Comment on “Planar Hall resistance ring sensor based on NiFe/Cu/IrMn trilayer structure” [J. Appl. Phys. 113, 063903 (2013)]

Comment on “Planar Hall resistance ring sensor based on NiFe/Cu/IrMn trilayer structure” [J. Appl. Phys. 113, 063903 (2013)]

(Received 27 June 2013; accepted 12 July 2013; published online 11 September 2013)

FIG. 1. Sketch of (a) Ring and (b) PHEB sensors with definitions of dimensions and angles. \hat{I} is a vector along the current forming an angle α to the x -direction.

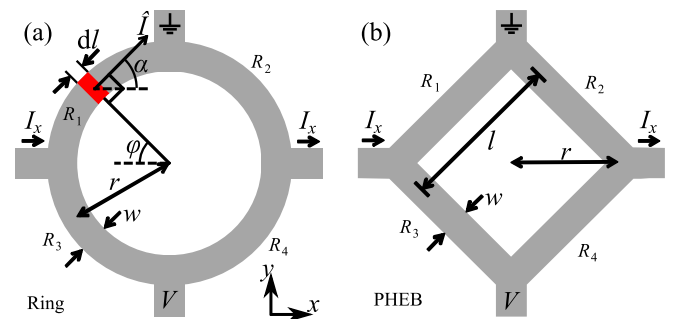
In a recent paper, Sinha *et al.*¹ compare sensitivities of planar Hall effect sensors with different geometries that are all based on the anisotropic magnetoresistance of permalloy. They write that the sensitivity of a planar Hall effect sensor with a ring geometry as shown in Fig. 1(a) is a factor of $\sqrt{2}$ larger than the sensitivity of the so-called planar Hall effect bridge (PHEB) sensor² of equal size with the geometry shown in Fig. 1(b). Sinha *et al.*¹ calculate the signal for a ring sensor to

where l is the length of each sensor branch. If the contacts to the two sensors are placed at identical positions, $l = \sqrt{2}r$, which leads to a ratio of Eq. (1) to Eq. (2) of $\pi/\sqrt{2}$ instead of the claimed $\sqrt{2}$.

However, we do not agree on the signal calculation for a ring sensor derived by Sinha *et al.*¹ We are able to follow the derivation of the sensor signal until their Eq. (4), which for a general Wheatstone bridge should read

which is a factor of π different from Eq. (5) in Sinha *et al.*¹

Comparing Eq. (10) with Eq. (2), it is clear that the magnetic field sensitivity of the PHEB geometry of Fig. 1(b) is a factor of $\sqrt{2}$ times that of the ring geometry of Fig. 1(a), i.e., 41% larger. The reason for this can be understood directly from Eq. (5). The terms that are quadratic in either $\sin\alpha$ or $\cos\alpha$ are identical upon a sign change of α and hence cancel out for a symmetric bridge geometry. Therefore, the only term contributing to the bridge voltage for a symmetric bridge geometry is that proportional to $\sin 2\alpha$, which comes from the off-diagonal terms of the resistivity tensor. This term clearly assumes its maximum numerical value for $\alpha = \pi/4 + n\pi/2$ with n being an integer and all other values

In addition, the length of each of the four sensor branches for the ring sensor is $r\pi/2$, which is 11% longer than the corresponding length of $l = \sqrt{2}r$ for the PHEB sensor. Thus, the total resistance of the ring sensor 11% is higher than that of the PHEB sensor. This unnecessarily added resistance contributes to the sensor power dissipation and the sensor noise.

In conclusion, we have analyzed the ring sensor design of Fig. 1(a) and compared it to the corresponding PHEB design of Fig. 1(b). Our analysis shows that the magnetic field sensitivity of the two sensor designs for identically behaving magnetic stacks is 41% higher for the PHEB design than for the ring design and that it can be achieved with an 11% lower bridge resistance.

$$V_{\text{Ring}} = \frac{r}{2wt} I_x \Delta\rho \sin(2\theta), \quad (10)$$
